From: Sierra-Lopez, Omar [Sierra-Lopez.Omar@epa.gov]
Sent: 8/1/2019 7:43:31 PM
To: Minter, Douglas [Minter.Douglas@epa.gov]
Subject: Fw: [EXTERNAL] Additional Information Regarding the Dewey Burdock Uranium Mine Project

From: Robinson, Valois <Robinson.Valois@epa.gov>
Sent: Monday, July 29, 2019 12:07 PM
To: Sierra-Lopez, Omar <Sierra-Lopez.Omar@epa.gov>
Subject: statement that no mines are present in Biological Assessment ...

Photo 3-B: Triangle Underground Mine Vent Shaft

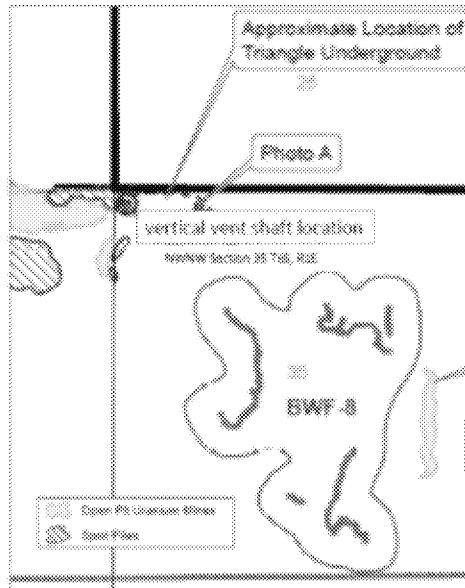
The issue is primarily if the shaft is determined to be a NLEB hibernacula. If a survey is completed that shows it is being used there would be some potential timing restrictions.

As per Shea Robinson (see email below) there is an abandoned mine in the project area. The vent shaft for that mine is pictured below.

There is a vertical mine shaft in Section 35 near Burdock wellfield # 8. Would you run it by your contacts at F&W, please?

I have included a photo and location map below. Maybe the bars across the shaft opening prevents bats from entering. Powertech measured the depth to the bottom of this vent shaft in April 2011 and found it to be 68 feet below ground surface with approximately 3 feet of groundwater.

Sounds good and if it is determined to be hibernacula there is no defined buffer for winter activities. It might be simpler to implement a buffer and be able to avoid the need for a survey as a survey itself could be a disturbance. depending on timing and method.
